STEWART BUILDING (L20-D57). GRADING AND DRAINING PLAN FOR RE: BUILDING AND SO #19 PERMIT APPROVALS. ENGINEER'S STAMP DATE JUNE 25, 1997.

RE: Drainage Plan for Stewart Building (L20-D57)

RE: Drainage Plan for Stewart Building (L20-D57) Received May 27, 1997

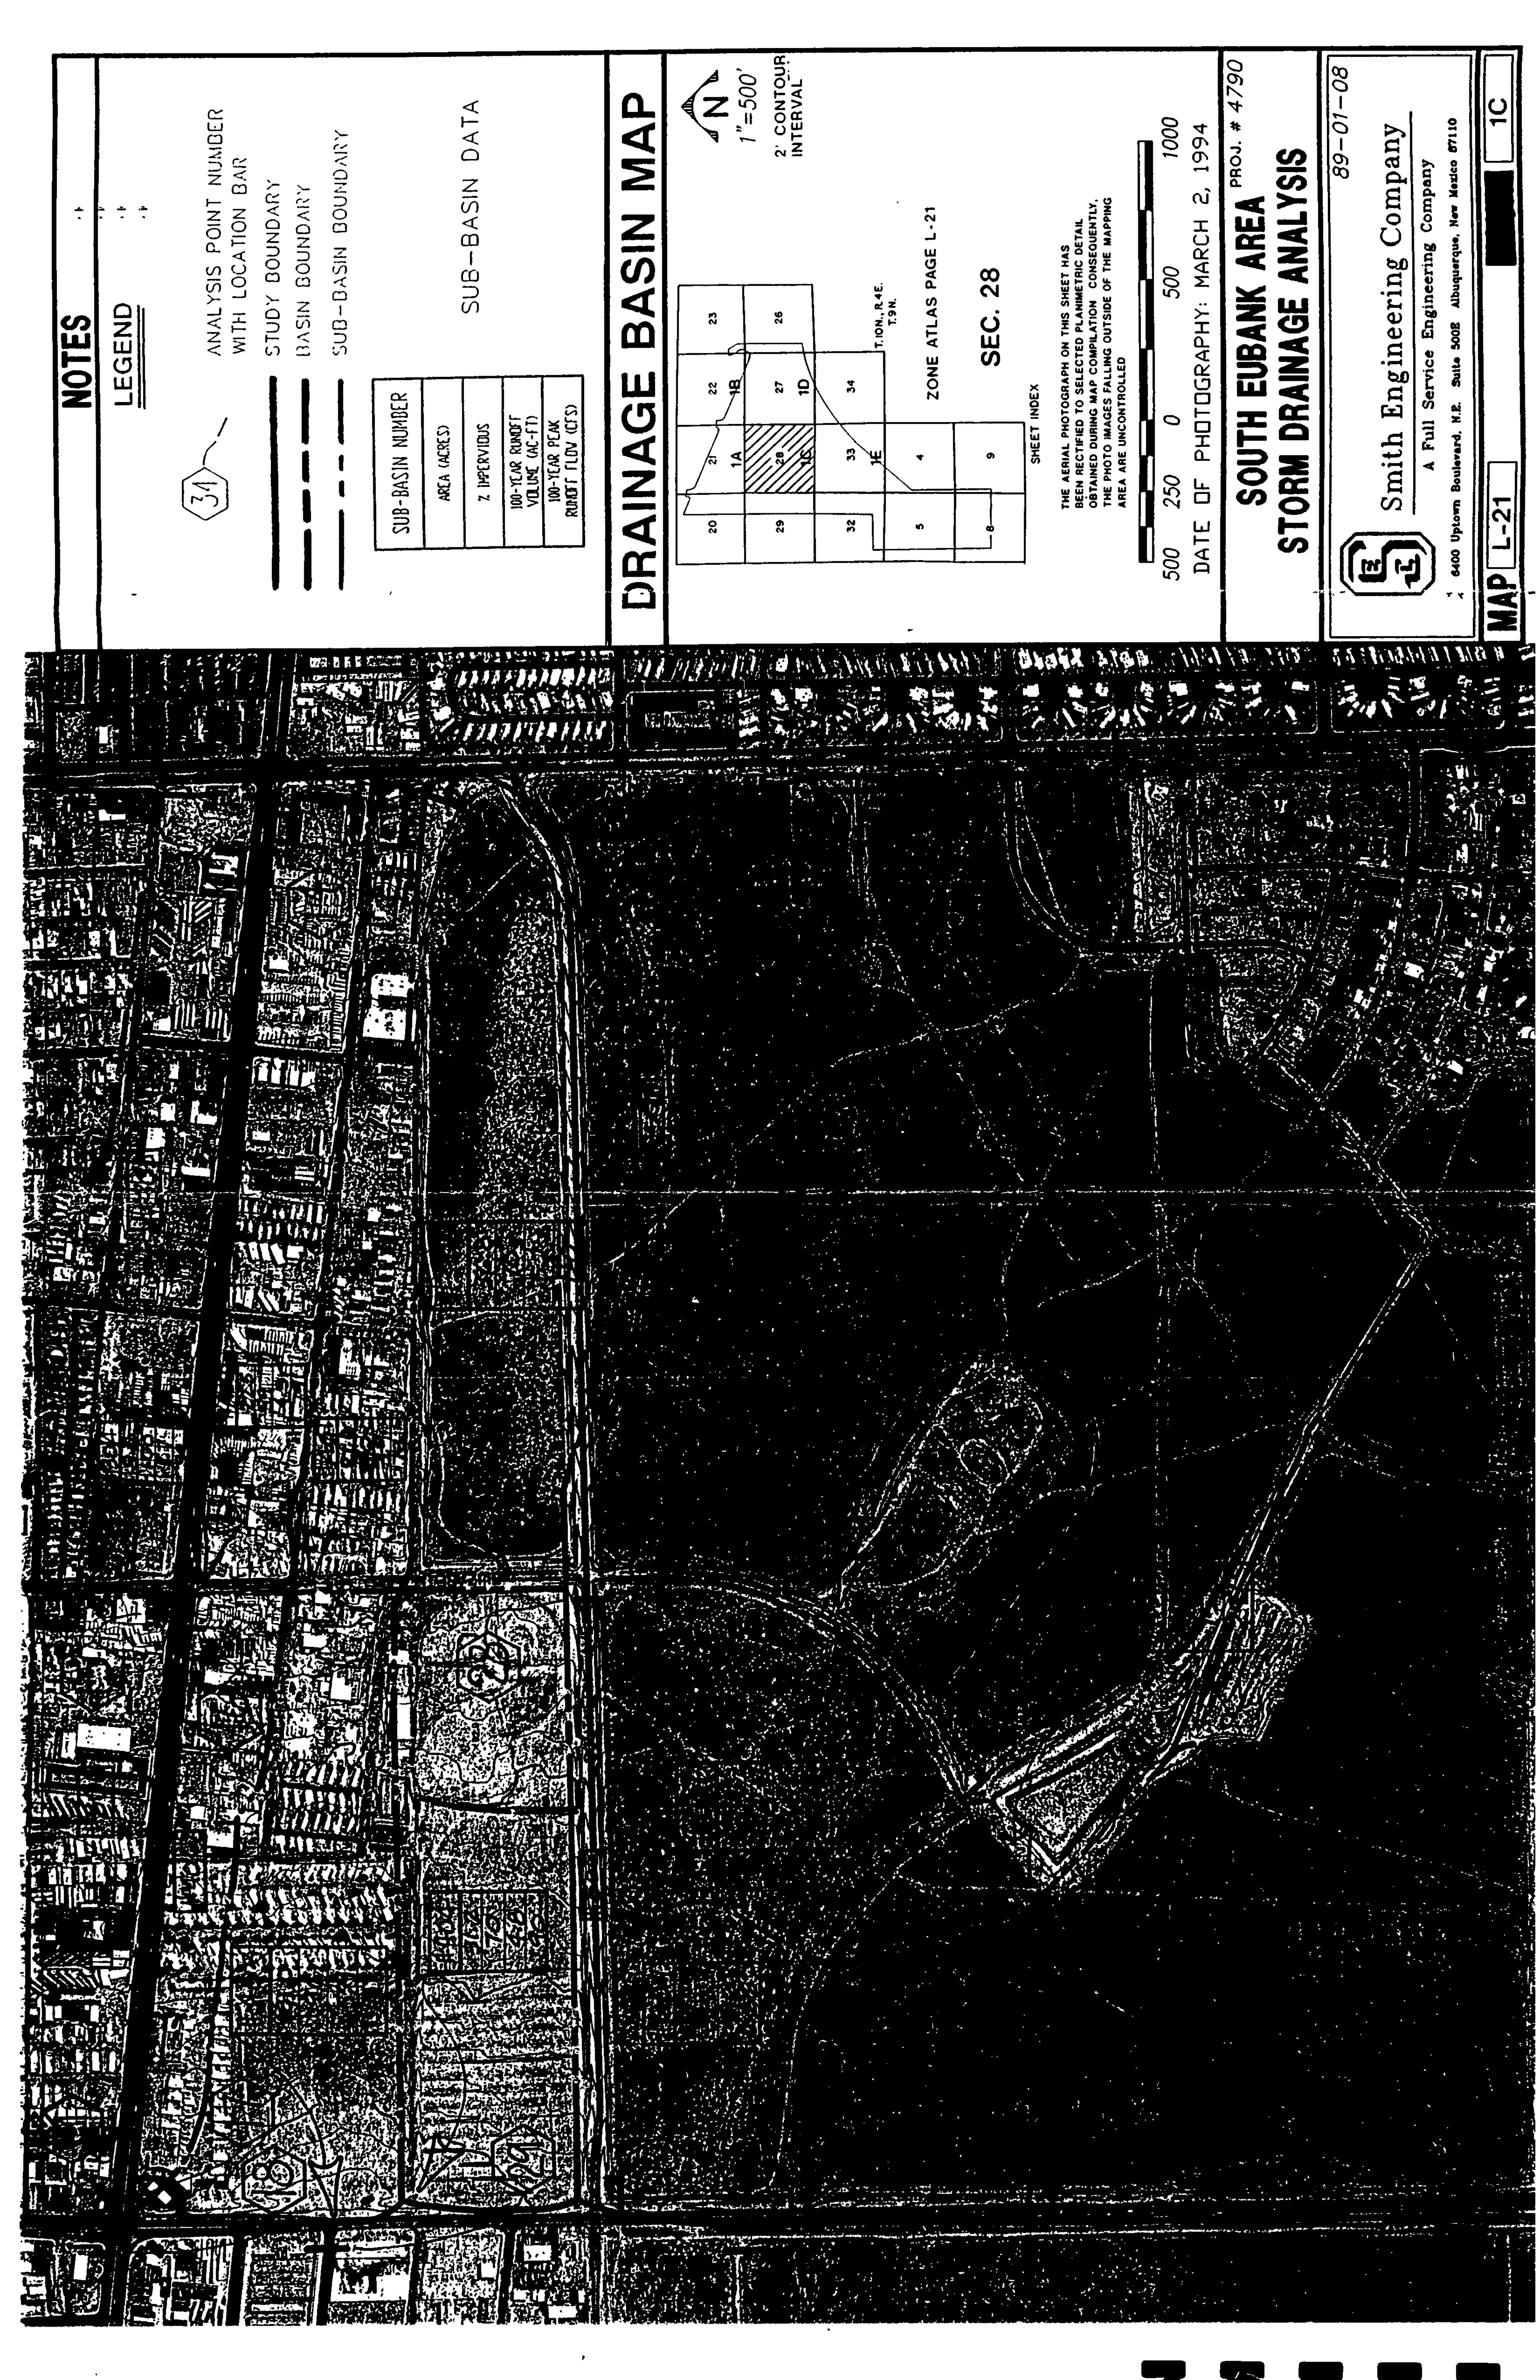
- 1. The construction of the sidewalk culvert in the City Right-of-Way will need to be processed through an SO #19.
- 2. Please submit the new plat with your next submittal. Otherwise, I need an agreement that allows cross lot drainage for the 10 lots.
- 3. When a property is developed you cannot discharge on to the downstream private property. If you do discharge on to the private property you need concurrence from the downstream owner.
- 4. Please give a detail of the proposed swales.
- 5. Please show the roof drains for the building and the mobile home.
- 6. Show proposed spot elevations for the proposed asphalt parking lot and 24 foot asphalt entrance.

7. If the pond depth is greater than 18 inches then the pond needs to be fenced.

- 1. The SO#19 for the sidewalk culvert will be processed at the time of construction.
- 2. A copy of the plat is attached. It has not been recorded at this time due to an issue between PNM and Mr. Stewart. As soon as this is resolved, Kym Dicome will sign the plat and it will be recorded. The attached FAX indicates Community Sciences Corporation latest attempts to bring this to closure. Please proceed with this drainage review assuming the plat will be recorded by the July deadline.

- 3. Per your request during our phone conversation on June 19, 1997, an erosion control berm has been added to the west property line of this site. This will prevent cross lot drainage until a permanent solution is incorporated with the next phase of development.

- 4. A typical detail for the swale has been added to the plans.
- 5. The direction of roof drain for the mobile home and storage building is not known. However, all of the flow from the storage building is conveyed to the pond via curb and gutter or valley gutters. Therefore, how the roof drains does not impact the drainage. Similarly, the mobile home drains to the northwest corner of the property as it does in its existing state. The erosion control berm which has been added to the plans ensures that the discharge point will be at the driveway. This meets the criteria we discussed on June 19, 1997.

- 6. The asphalt drains for the finished floor elevation of the storage building to the curb and valley gutters. Therefore, additional spot elevations are not needed. Existing flow line elevations have been added at the driveways. This provides elevations at the four corners.

- 7. A fence has been added around the pond.
